Project Title: Rural Initiative (New Cemetery)
Project Location: Cedar City Utah, 37.648914, -113.090451

The purpose of this amendments is to:
A. Extend the bid due date and time to March 3, 2023, at 10:00AM (CT).
B. Provide Bid submission/opening instructions.
C. Provide answers to vendor RFI/Questions.

Vendor RFI Questions and Answers

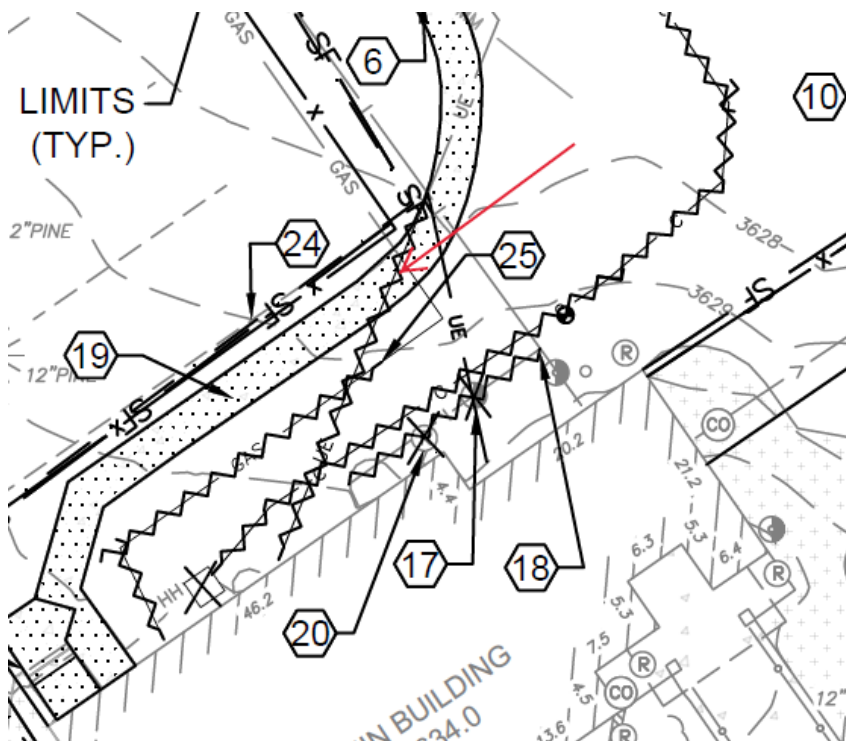
4. On Sheet E101, keyed note 2 states “Intercept existing underground electrical service and extend to new location as shown.” It is unclear where this feed originated and where it currently end up. Please clarify.

D101 and E100 are missing a demolition note showing that the existing underground electrical line is to be demolished. The feed originates underneath the building addition foundation and requires relocation exiting the building to E101 Keynote 3. See sketch below.

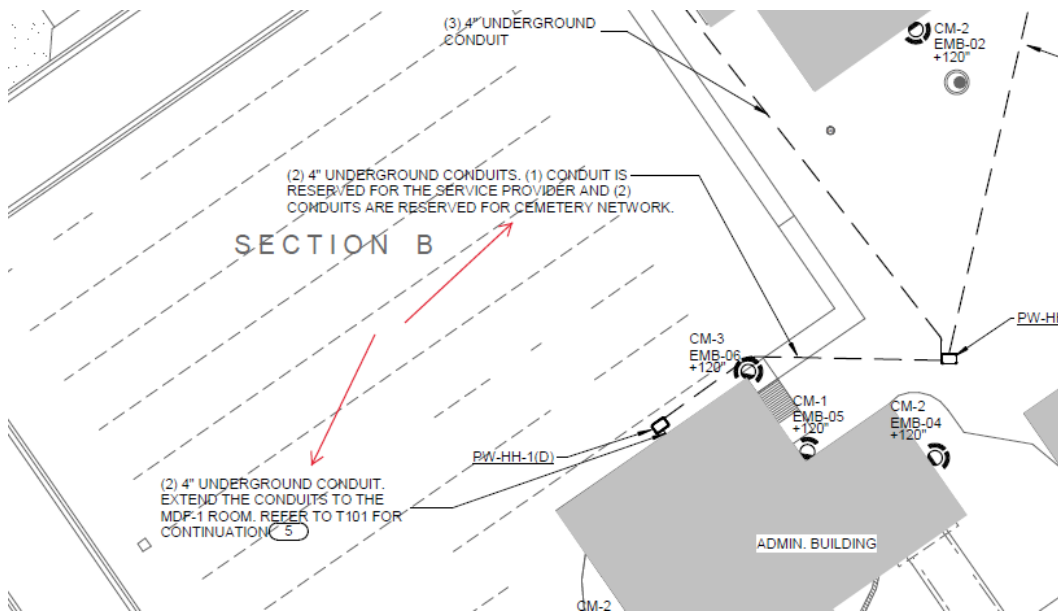
- On Sheet T100, the note right above section B states (2) 4" conduits. One for the service provider and 2 for cemetery network. Please clarify the number of conduits needed.

This is an error. Only (2) 4" conduits are required at this note.
